**Town of Kittery  
Planning Board Meeting  
February 22, 2024**

**ITEM 2—283 US Route 1—Master Site Plan — Final Review**

**PROCESS SUMMARY**

Title:	EXTERIOR ELEVATIONS
Sheet No.:	A2.01

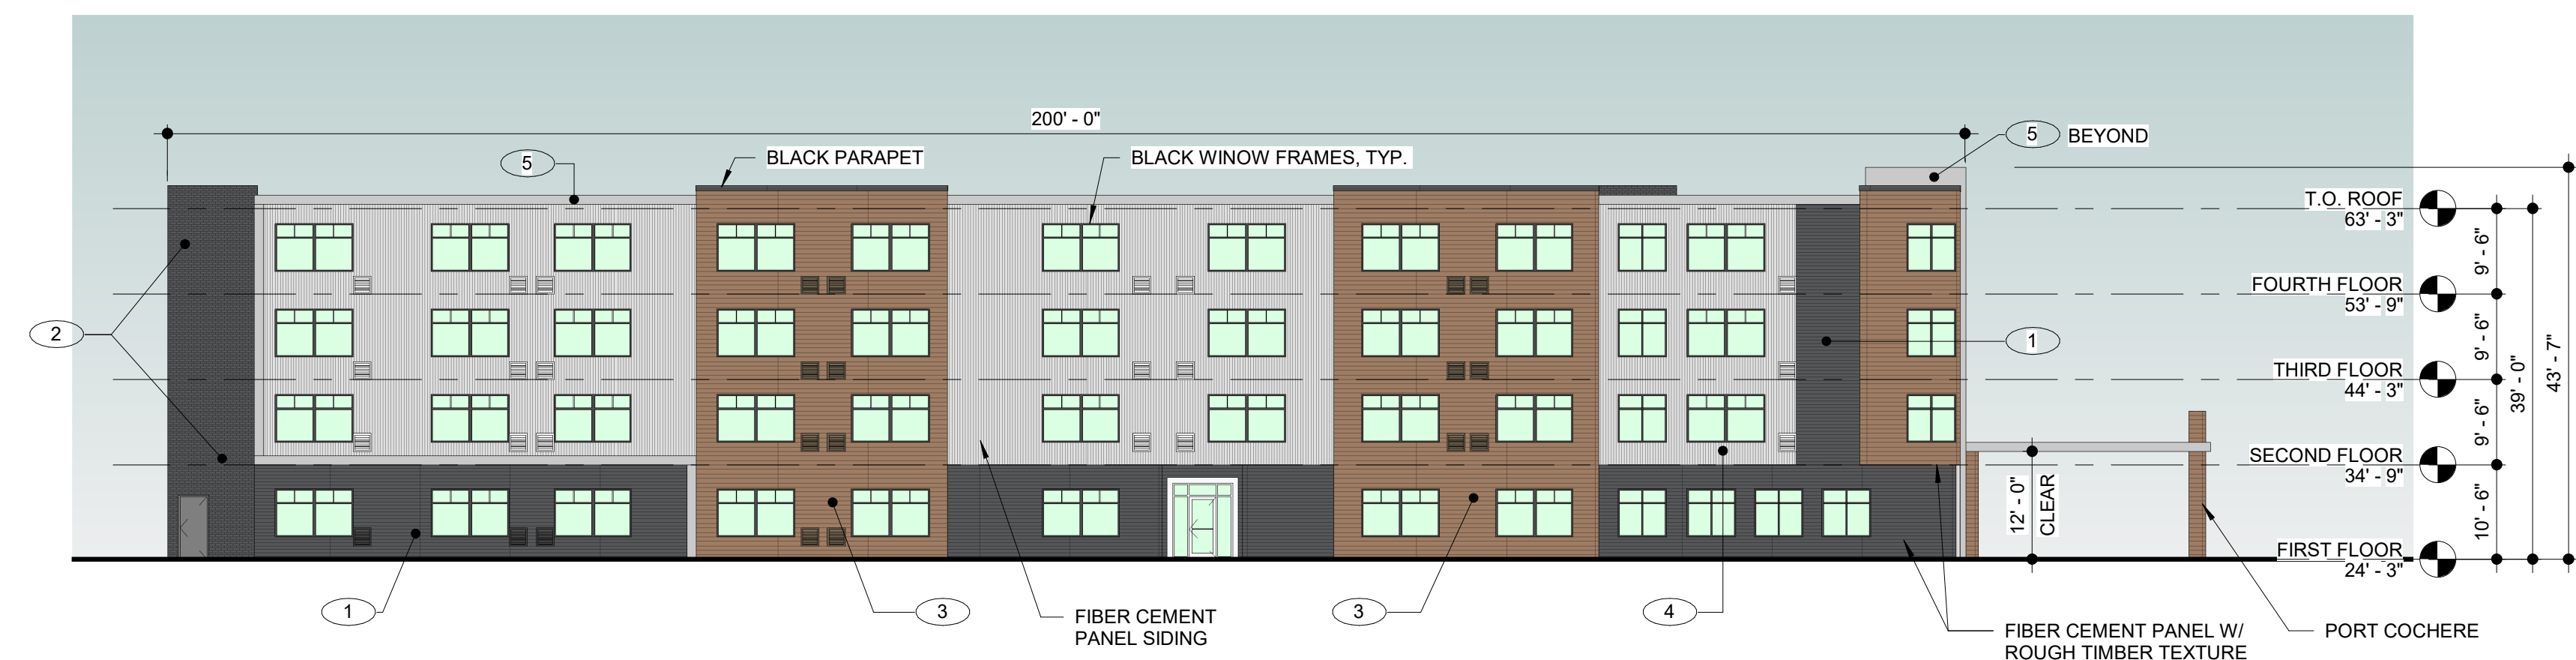
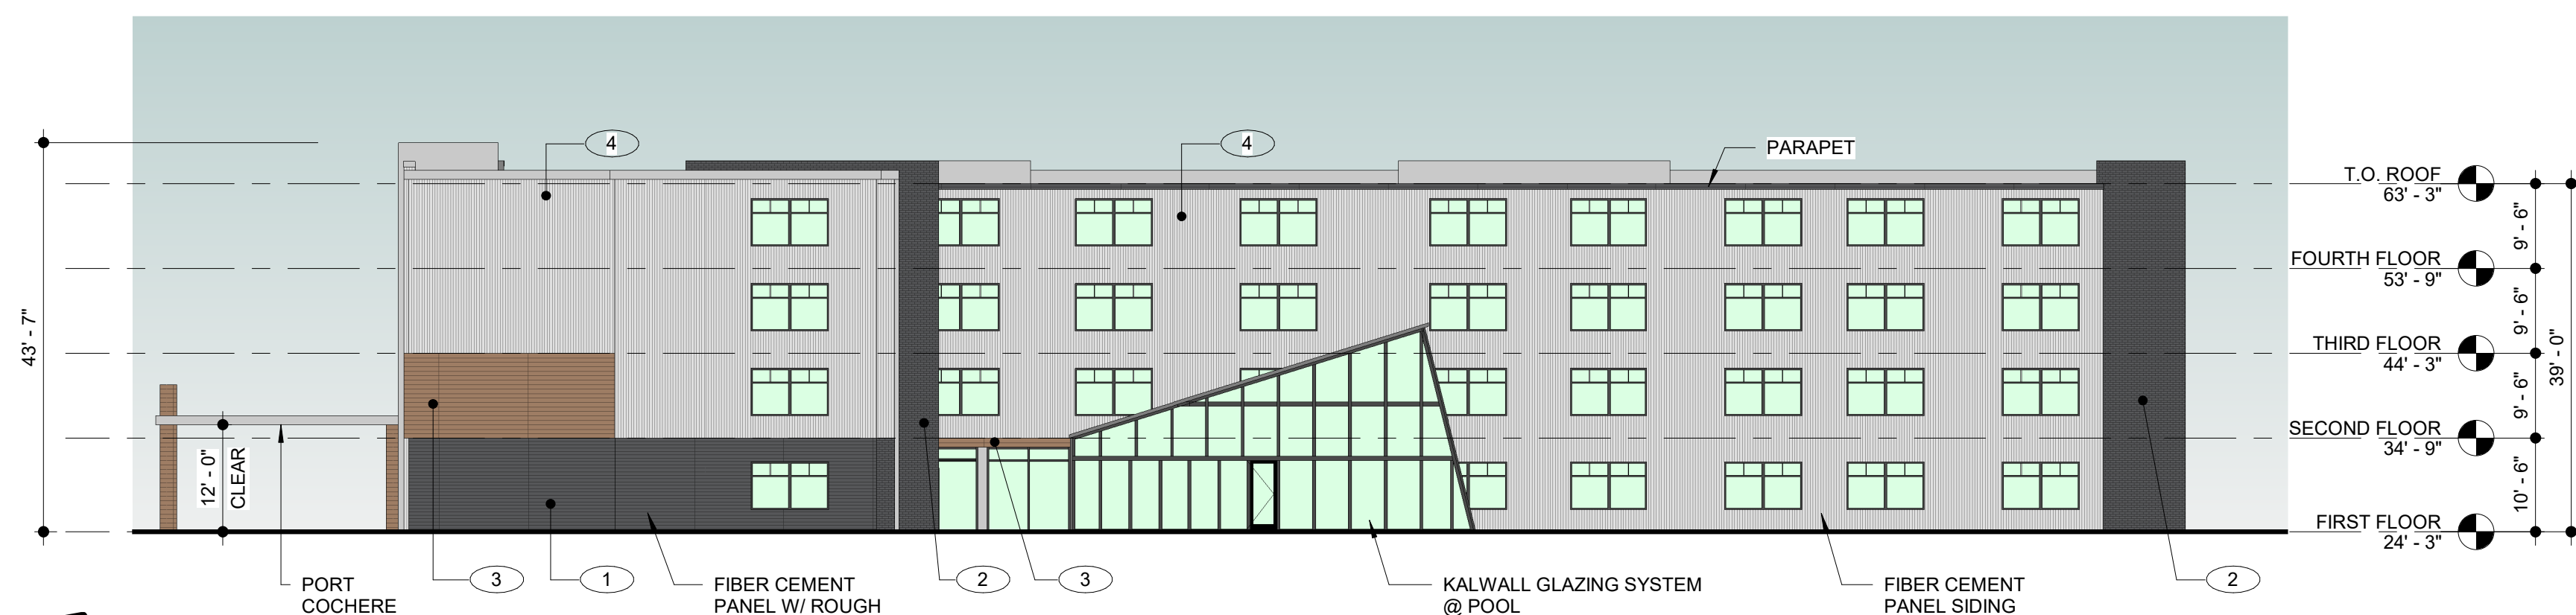
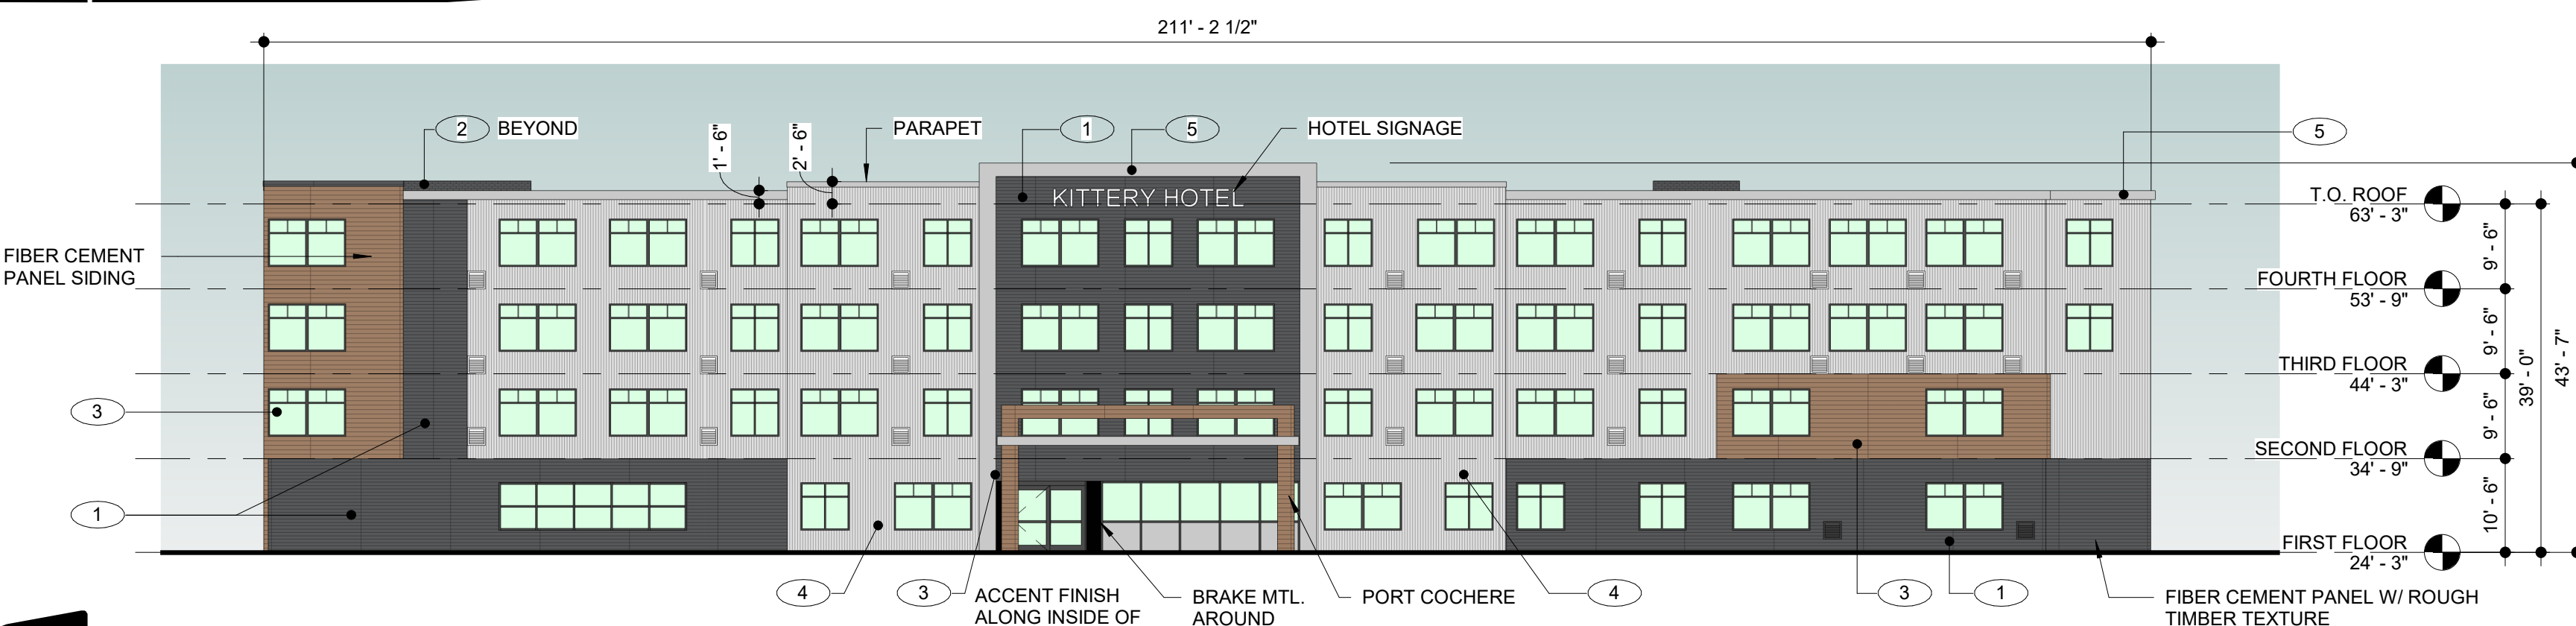
- a. The elevations also show the tops of the parapets jutting above the “top of structure” line. Parapets are excluded from height calculations, as they are above the roof beams of the building.

PHASE 1 - SITE PLAN  
 SCALE: AS SHOWN  
**C-102.1**

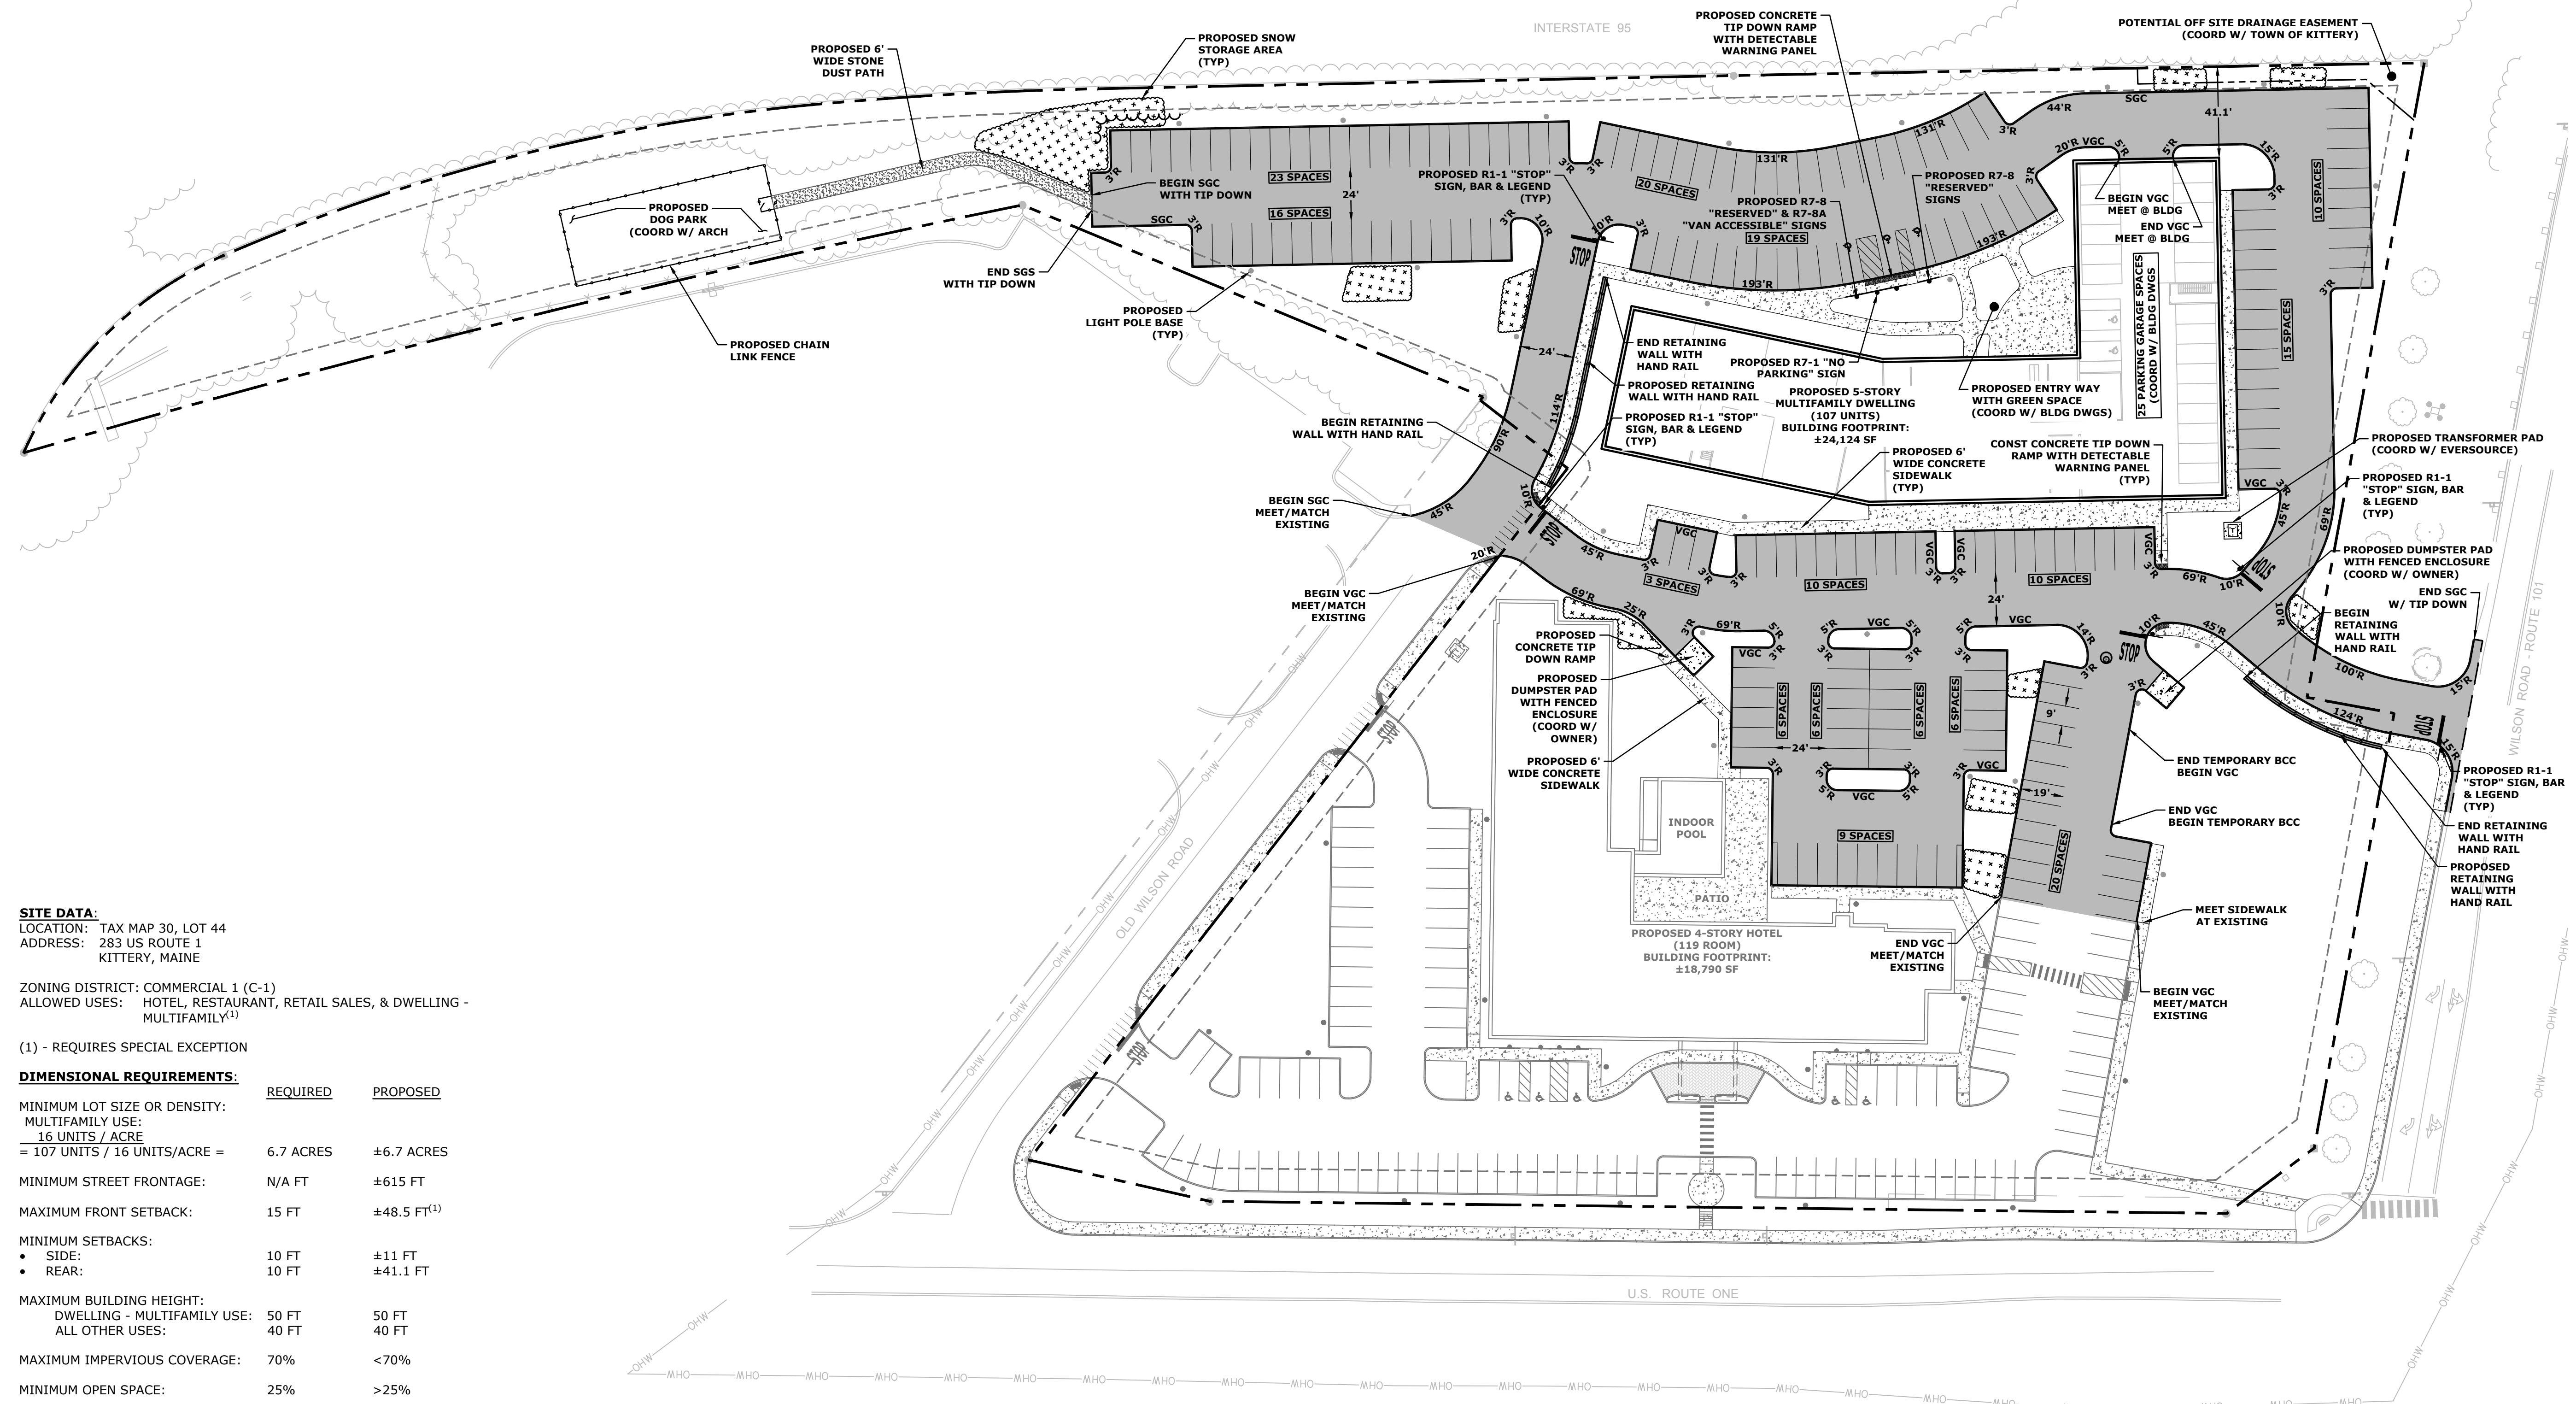
- 151 9. Following feedback from the planning board, the applicant has moved the snow storage  
152 areas away from the Route 1 ROW. Note #18 on the site plan details snow removal and  
153 storage procedure.

- 154 a. There is a second “Note #13” also detailing snow removal on the site plan. This  
155 appears to be a typo and should be removed before final plan recording.

1. The impervious cover does not match the quantity on Sheet C-103.
2. Clarify the label "Proposed Dog Park (Coord w/ Arch)".
3. Site Note 4 references centerlines. Please remove.
4. There are two Site Note 13s.
5. Site Notes 18 and 13 (the second one) are the same.
